TER : Q-410
pg 1/2

COMPONENT TASK EVALUATION REPORT

SYSTEM/COMPONENT NO. 03-315A D.G. 102R	TDI PART NO. 03-315A	INITIATOR <i>K. M. Taylor</i> SIGNATURE	DATE 3-29-84	ORGANIZATION <input type="checkbox"/> ENGINEERING <input checked="" type="checkbox"/> QUALITY
--	-------------------------	---	-----------------	---

INT. CYLINDER BLOCK

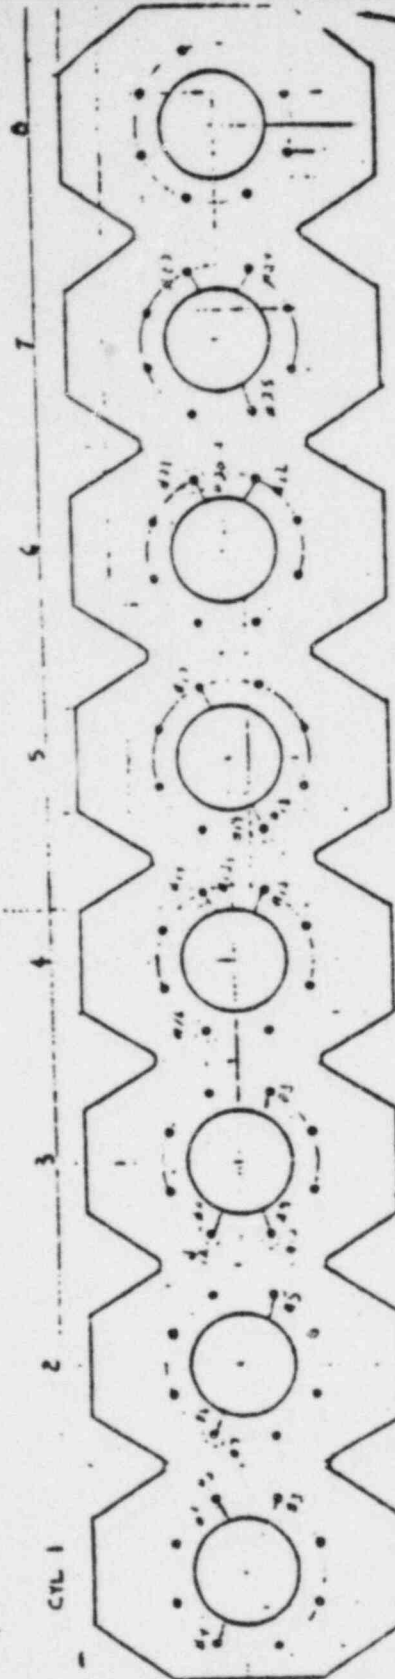
Per Performer LP on all cylinders Per CR-6-1
all cylinders unsat.

LOCATION	SIZE (INCHES)	DESCRIPTION	ACTION (ACCEPT/REJECT, AND COMMENT AS NECESSARY)
1 See Sketch	1/2"	Linear	Res. Cylinder #1
2 See Sketch	External throat 360°	Surface Pitting	Res. Cylinder #1 Best effort Performed
3 See Sketch	1/8"	Linear	Res. Cylinder #1
4 See Sketch	1/2"	Linear	Res. Cylinder #1
D. ACCEPTANCE CRITERIA	4.2	OPERATOR <u>V. H. [Signature]</u> Level <u>VII</u> Date <u>3-25-84</u>

RECOMMENDATIONS: FORWARD TO DESIGN REVIEW FOR EVALUATION AND ALSO TO SEO AND LSU FOR INFORMATION ONLY. Attached IR is UNSATISFACTORY- see sheet 2 for recommended disposition

DISPOSITION DETAILS: *Follow Procedure 1 outlined on page 2*
